PLAN OF BUILDING

ON PLOT No 6/1 SHEET FIS SUDDER BAZAR Q8

*A amended plan
of Building on plot No 6/1 sheet
Sudder Bazar Quarter
Scale 8=1"*

*Amended plan
of Building on plot- No 6, Sheet F 15
Subber Bazar Quarter
Scale 8"=1"*

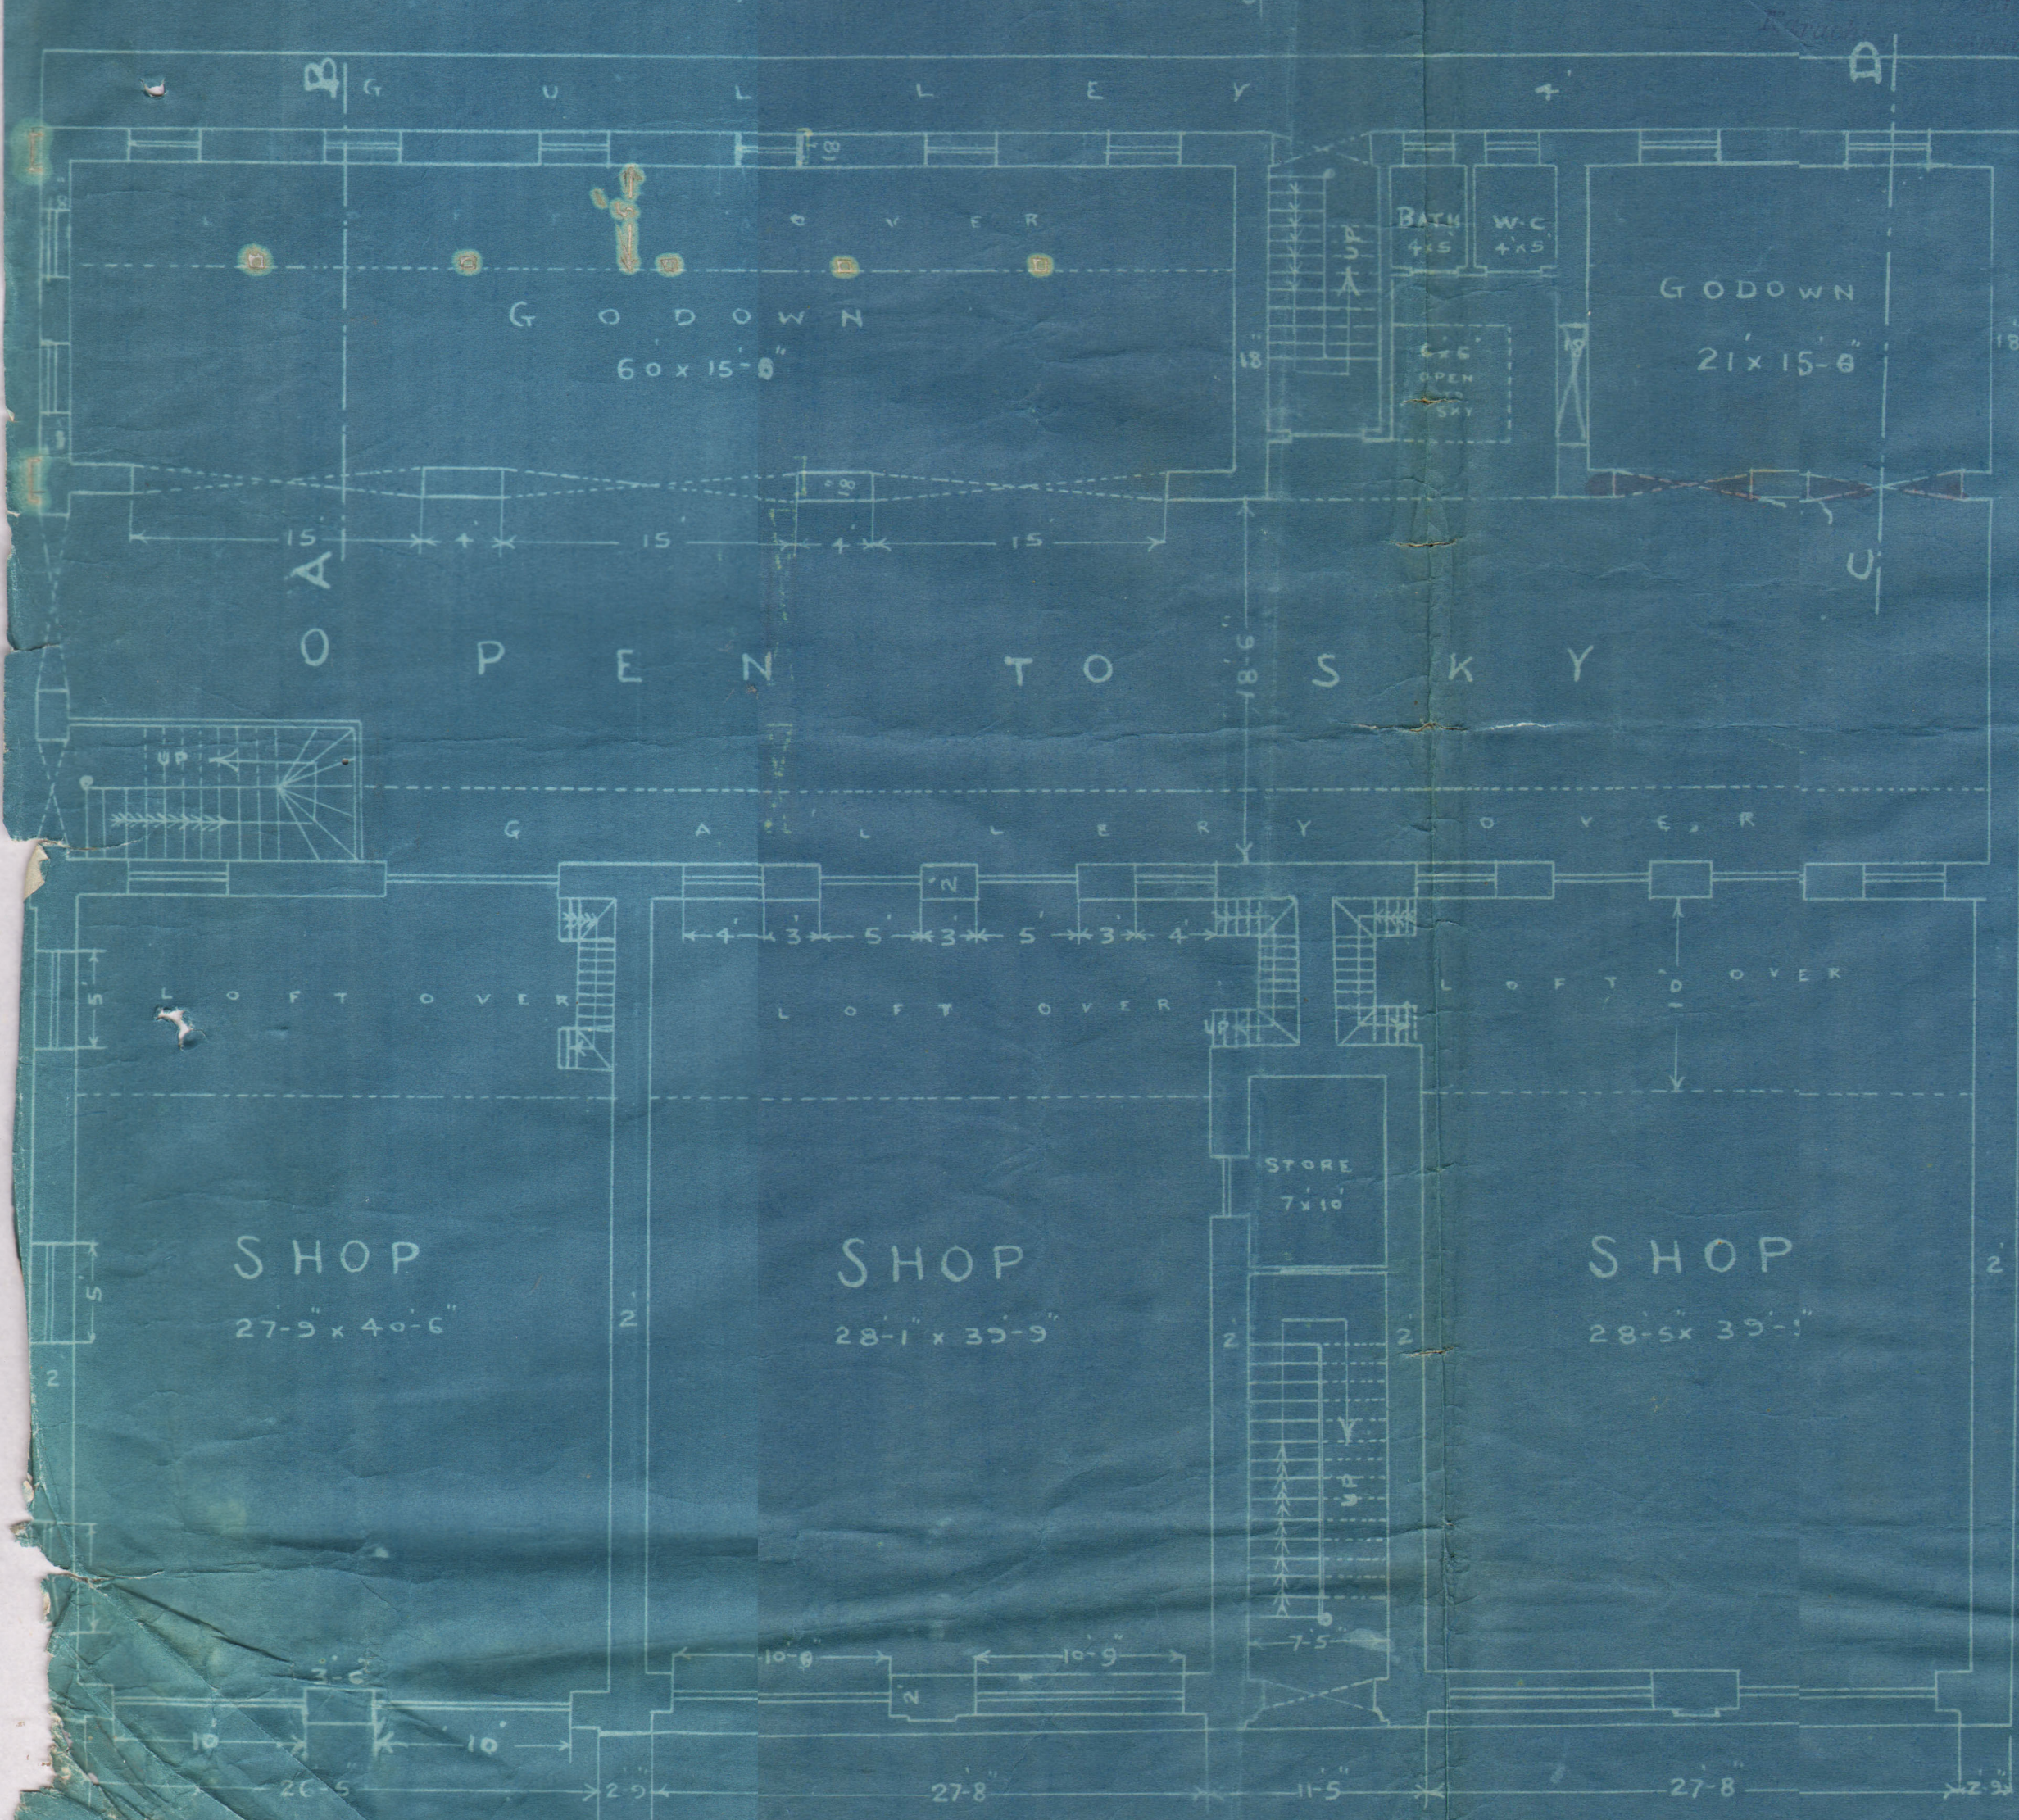
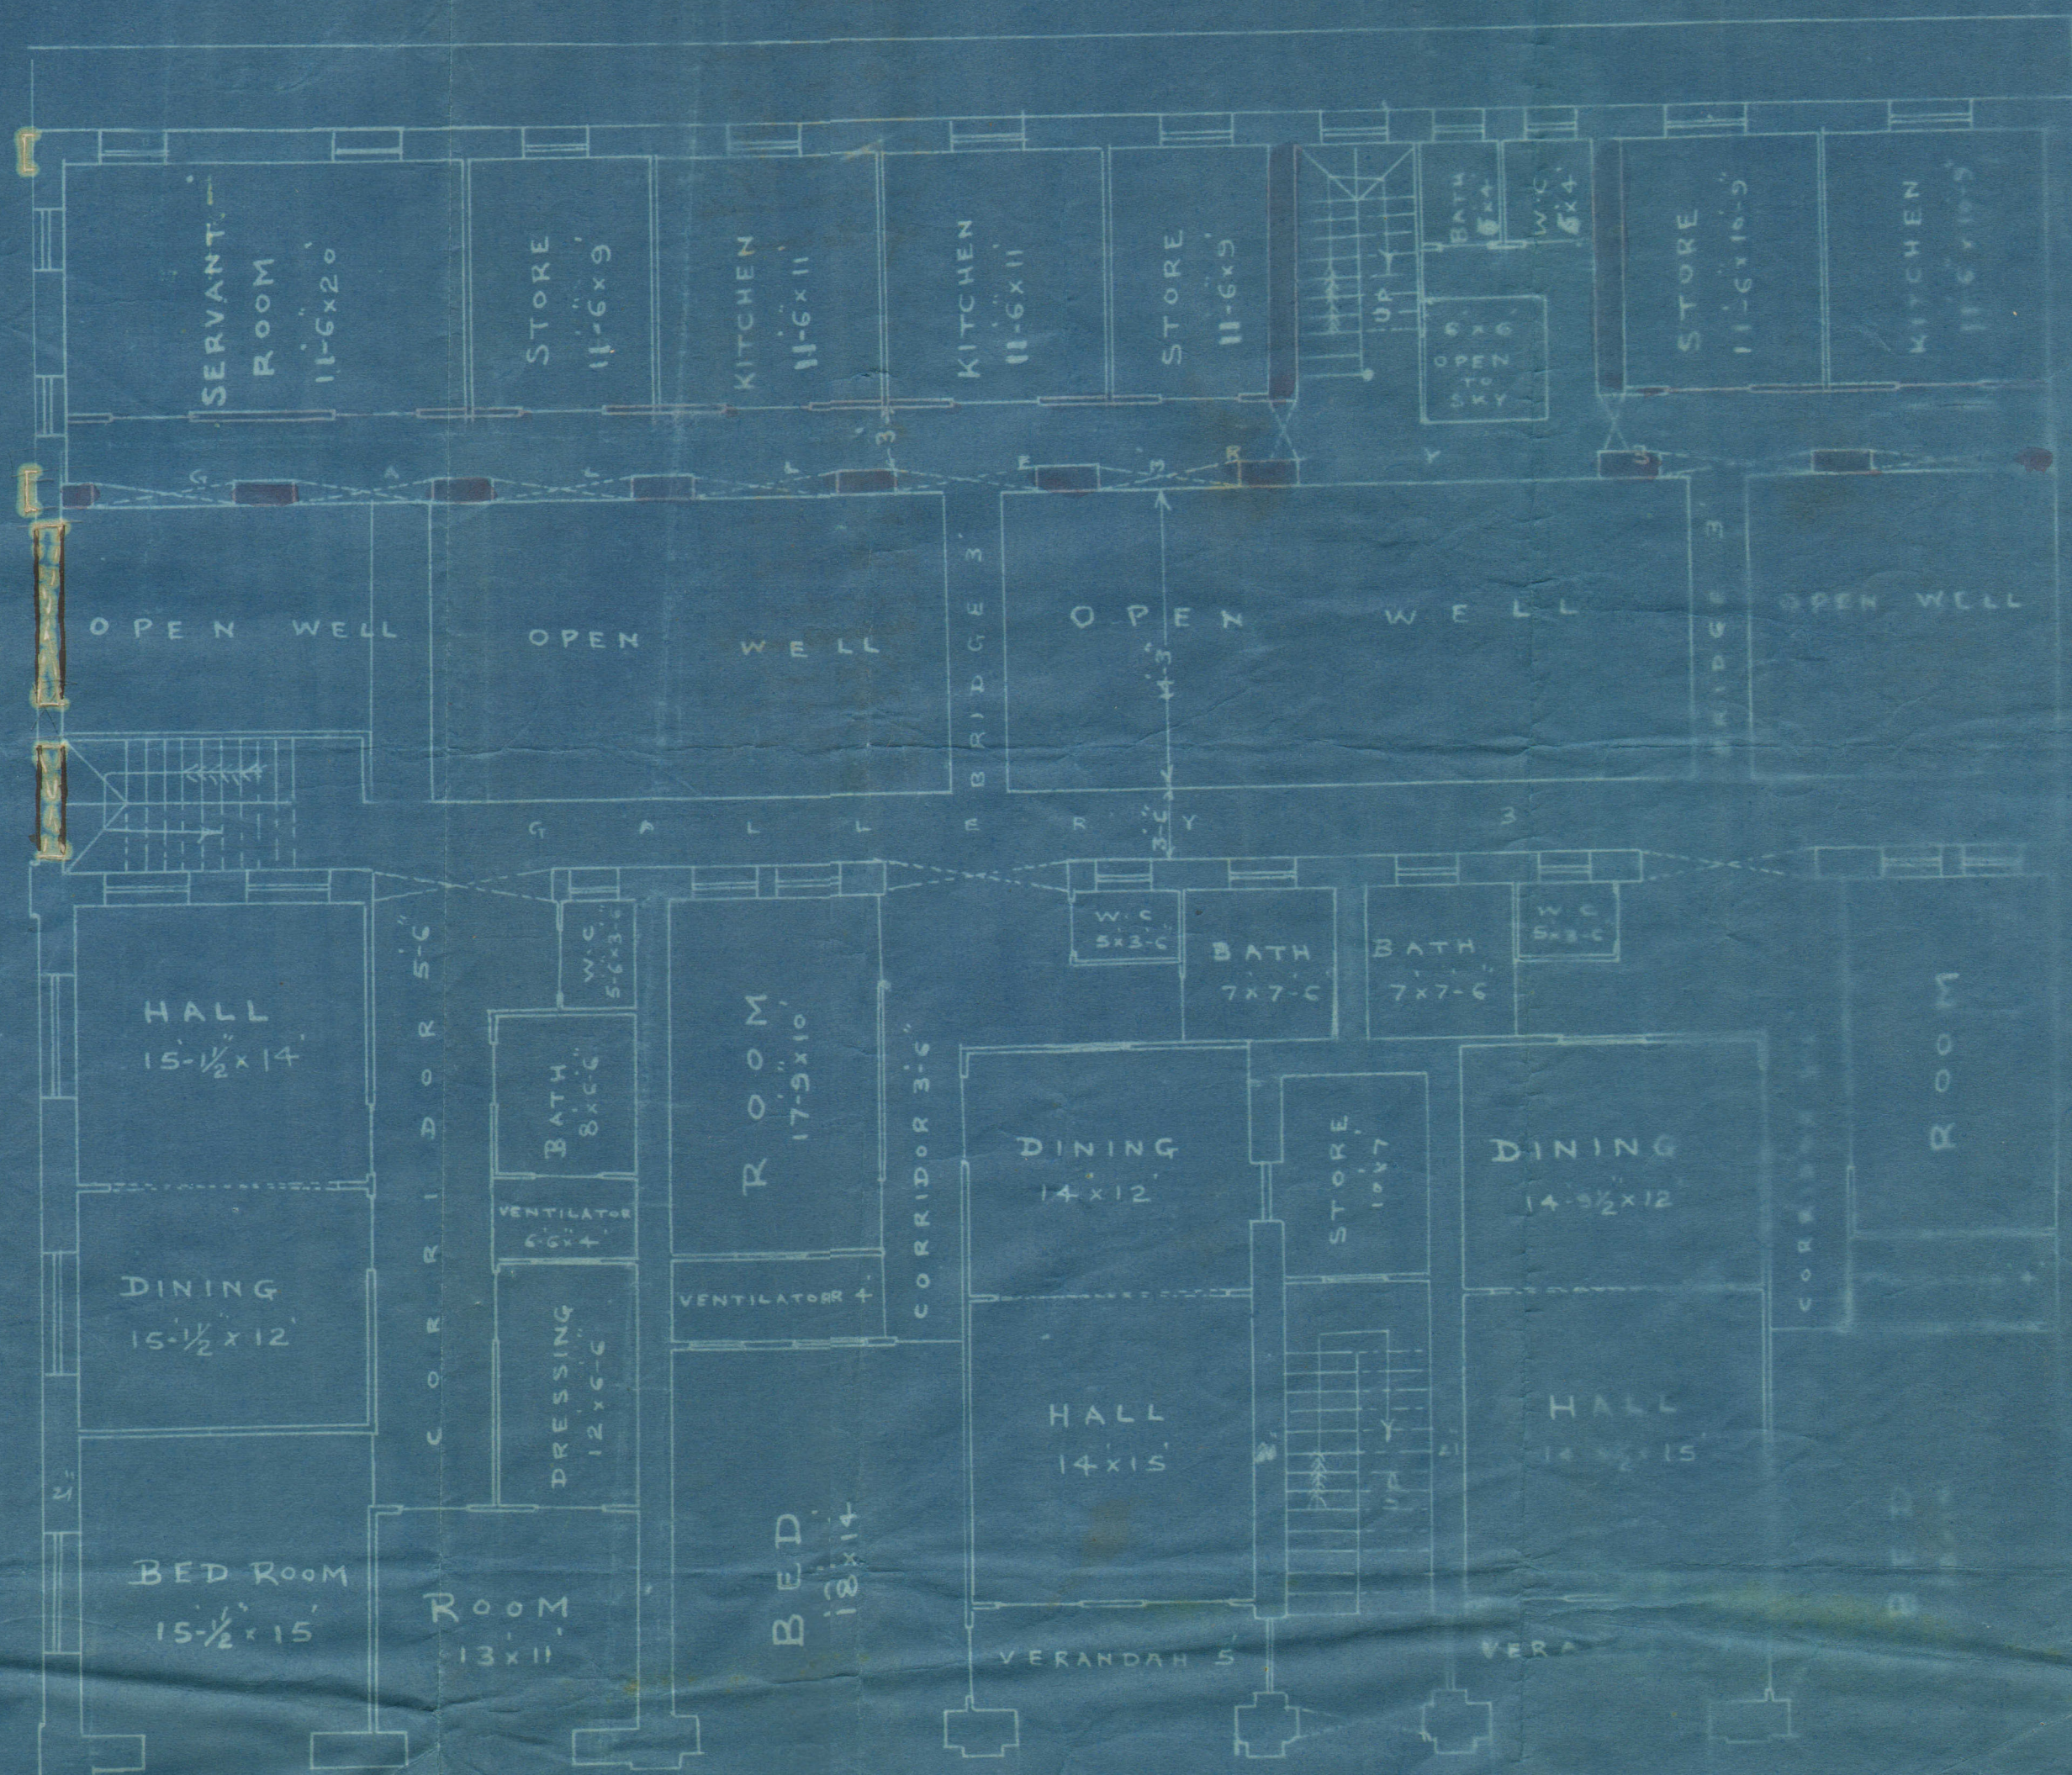
With reference to the
 beg to report the amends
 - Meats shown on ground floor
 are not objectionable.

With reference to the amends
 Meats proposed on 1st floor i.e.
 Carrying of front gallery
 wall right up to the level of
 the roofing is most objectionable.
 as it will make the rooms
 very dark.

Carrying of the front wall on
 1st floor is meant only to
 carry the loads of the floors

which otherwise would come on
 W & D wall. As the proposed wall
 is with open arches it does not
 affect light & air there is no
 objection in granting permission
 S. B. haime for 23/9/9
 signed 23/9/9

With reference to his letter dated 19th Instant with an amended plan for the building under construction on plot No. 6/1 F-15 Sadar Bazar Quarter Mr. Shandas Kedumal is informed the same is duly approved and returned herewith to proceed with the work in accordance with it.
